**Re: 7731 Fernbank Road – Proposed Crain’s Pit
Addendum Traffic Letter Report
City of Ottawa, Ontario**

The purpose of this addendum traffic letter report is to provide an update to the original “Transportation Brief¹” (December 21st, 2015) prepared by McIntosh Perry. The original study evaluated the traffic-related impacts to the proposed pit and quarry located at 7731 Fernbank Road in the township of Goulbourn, within the City of Ottawa. The revised site plan is illustrated in Exhibit 1.

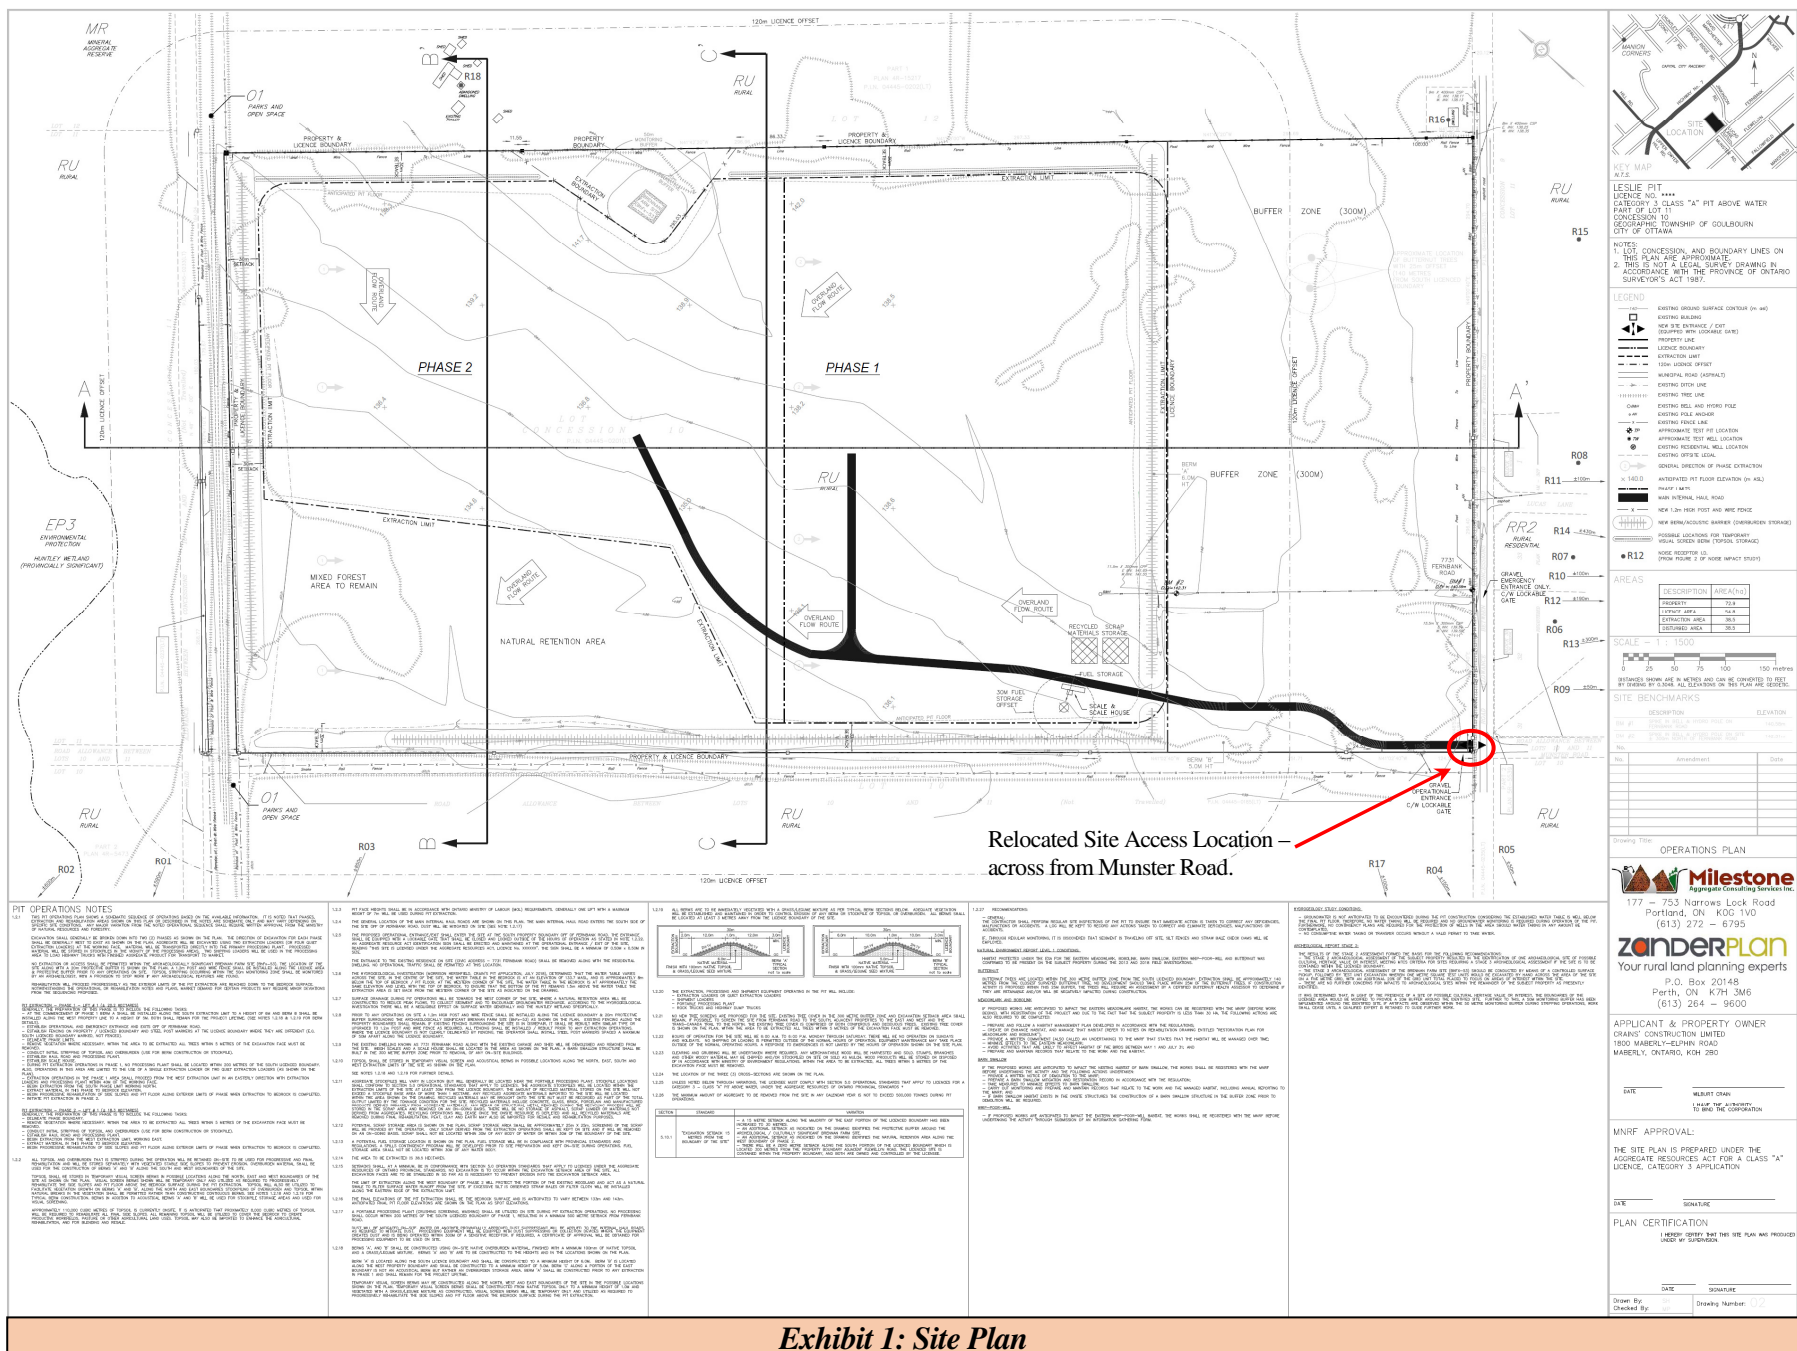
The following changes have occurred since the last submission:

- The proposed site access has been relocated across Munster Road. The original site plan had assumed the access would be located east of Munster Road; and
- The proposed pit is expected to produce a maximum annual tonnage of 500,000. The original study assumed 1,000,000 tonnage per year.

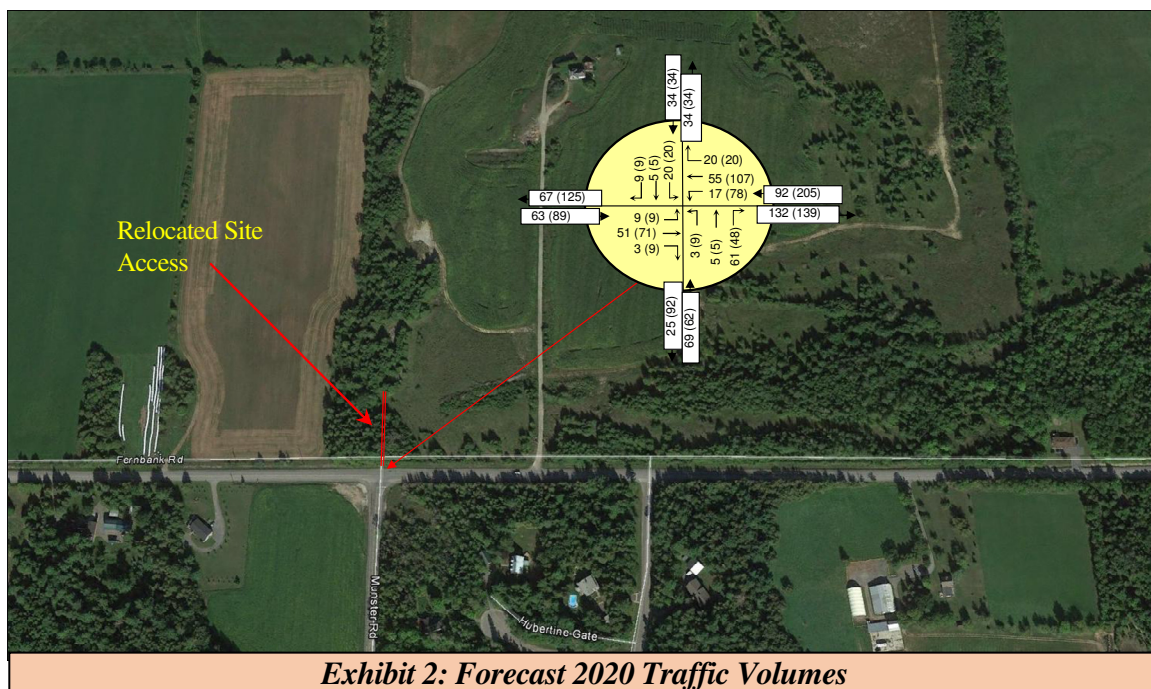
Exhibit 2 below illustrates the forecast traffic volumes with the revised site traffic volumes entering/exiting the proposed relocated site access opposite Munster Road. The same forecast background traffic volumes were used from the previous 2015 Transportation Brief². The same distribution patterns were also used for the revised site traffic volumes as the original study (60% north via Jinkinson Rd; 25% west via Fernbank Rd and 15% south via Munster Rd).
